TAKE 5 OIL CHANGE

AT 820 PANTOPS CORNER WAY

ARB FINAL SUBMISSION #1
SEPTEMBER 7th, 2021

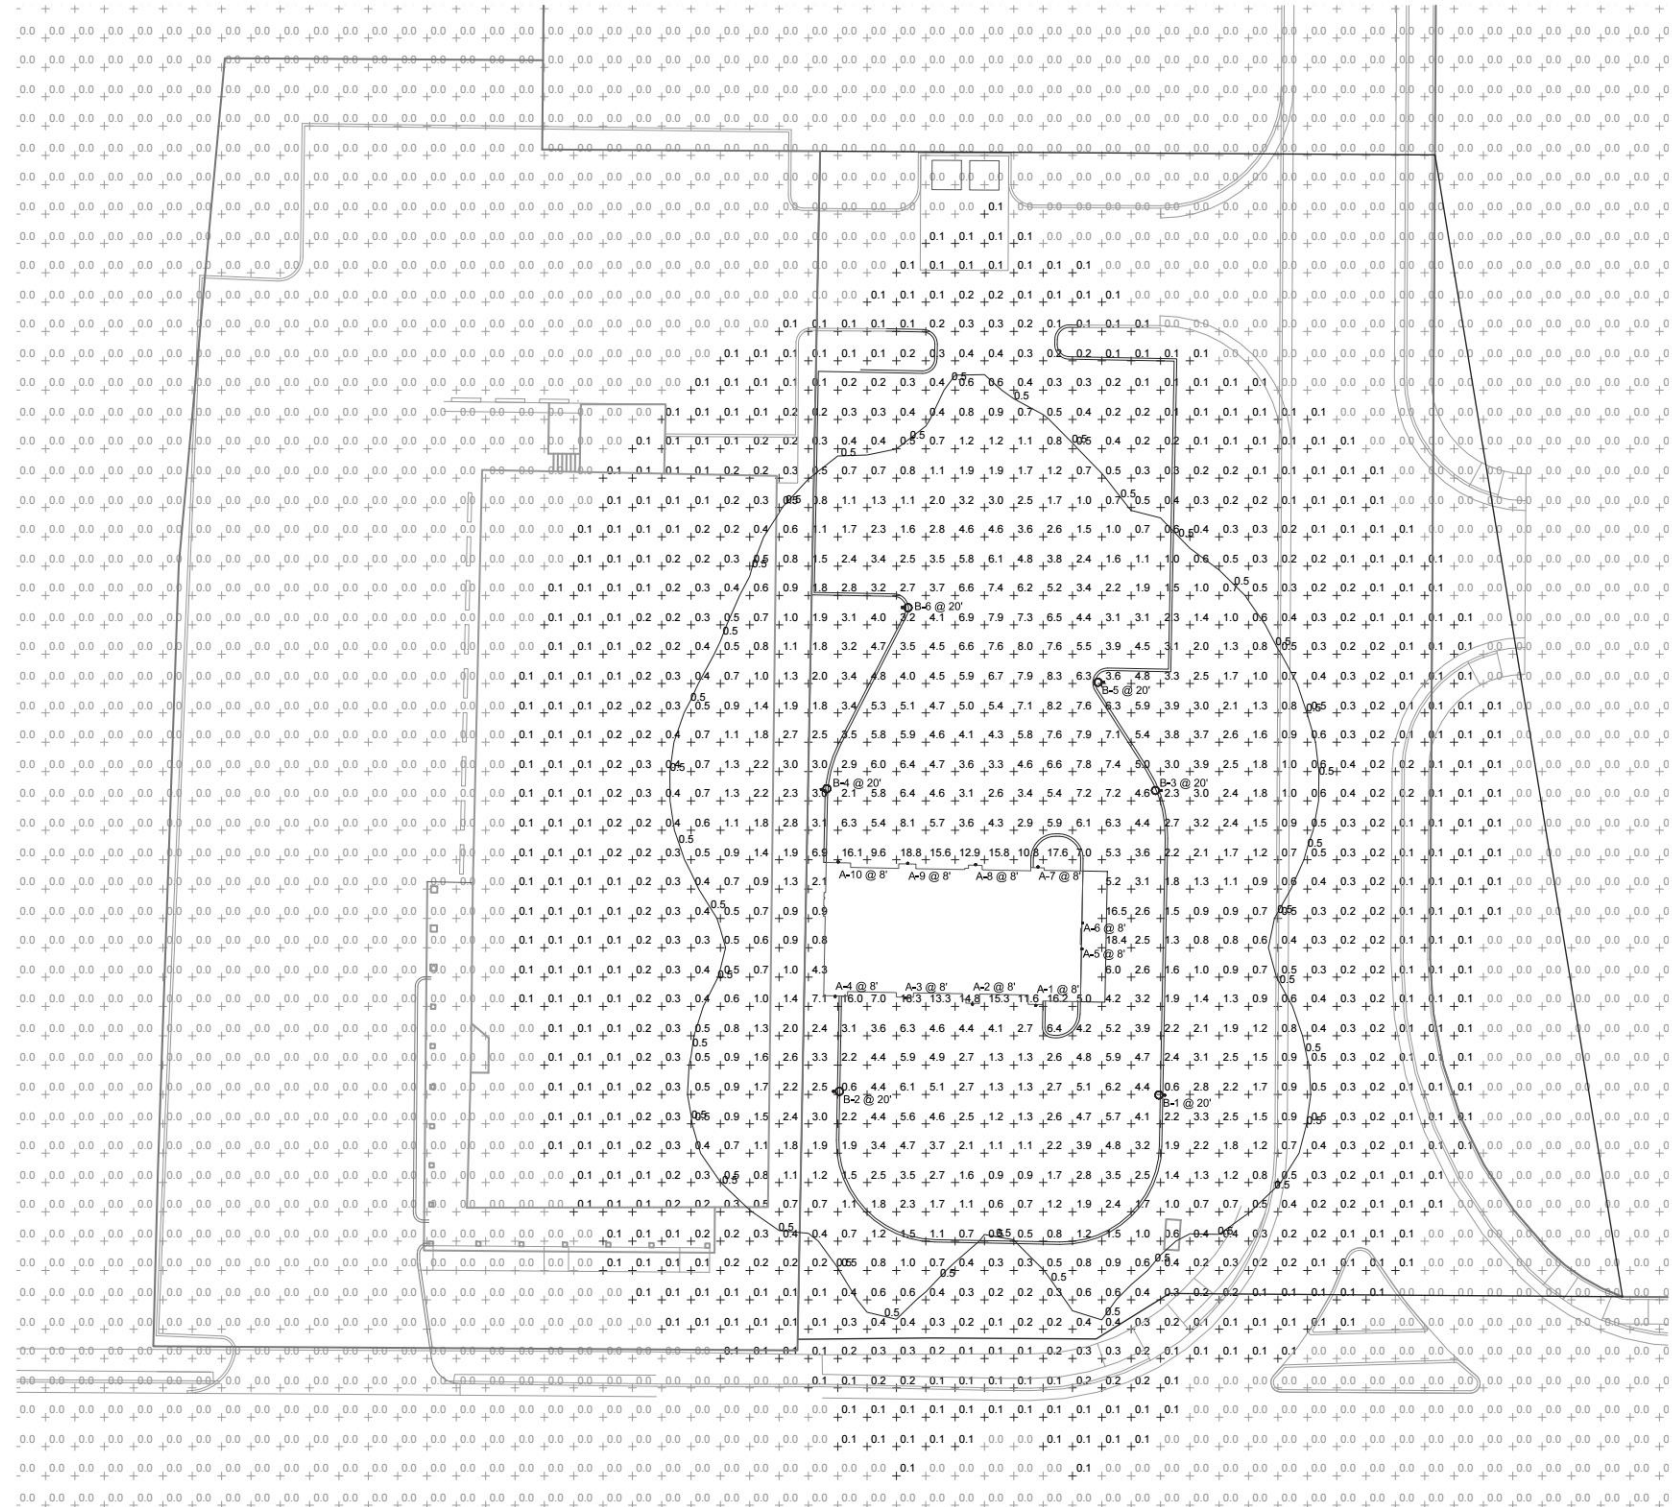
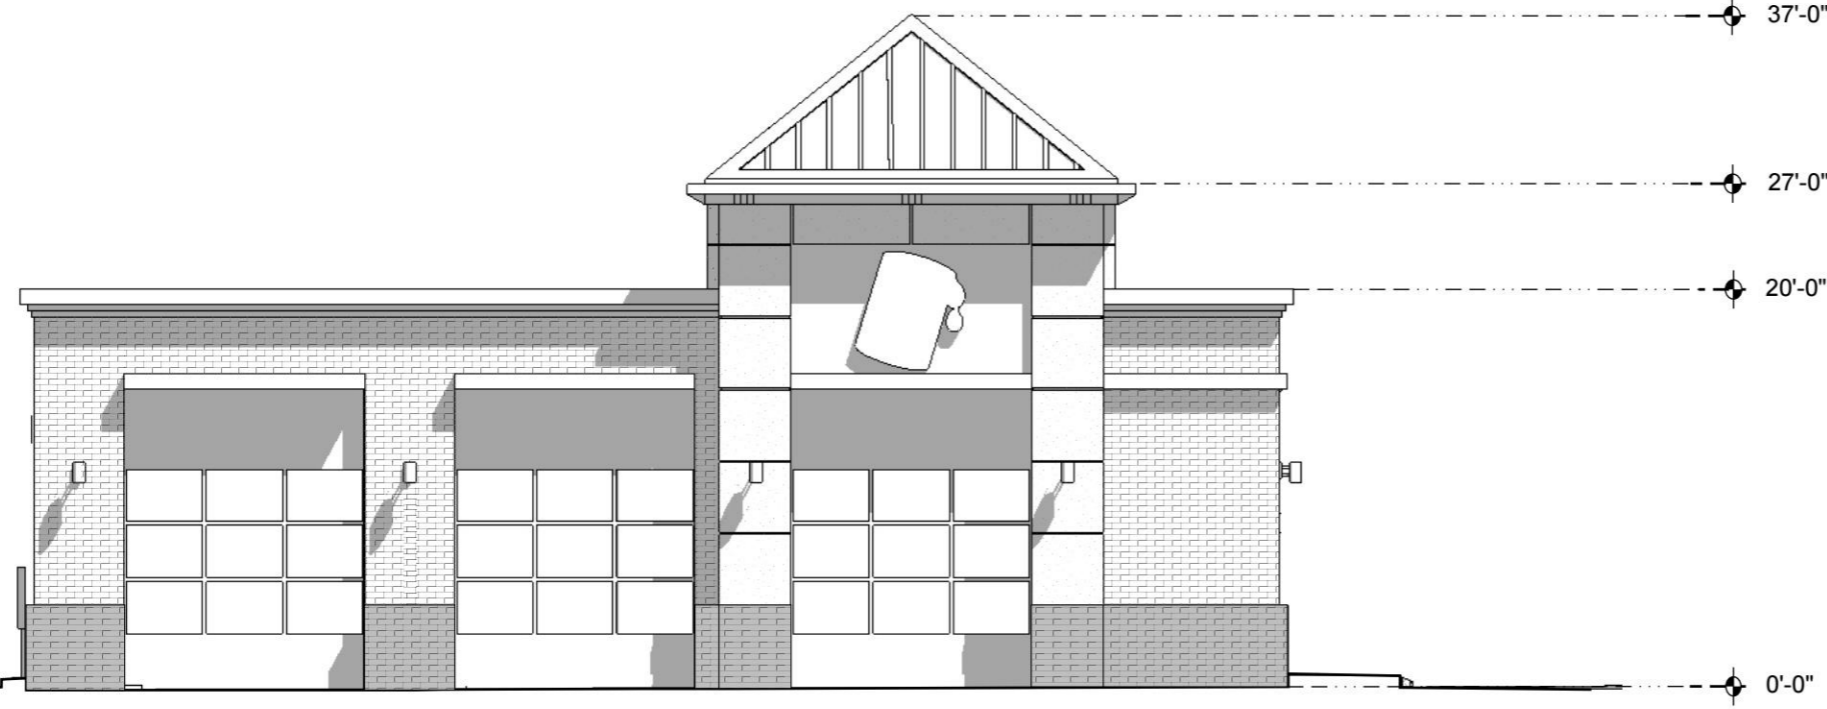
6. Provide a complete lighting plan with the final site plan.

Response: A lighting plan showing proposed pole lights and exterior surface-mounted sconces has been included in the final site plan and is included on page 20 of this document.
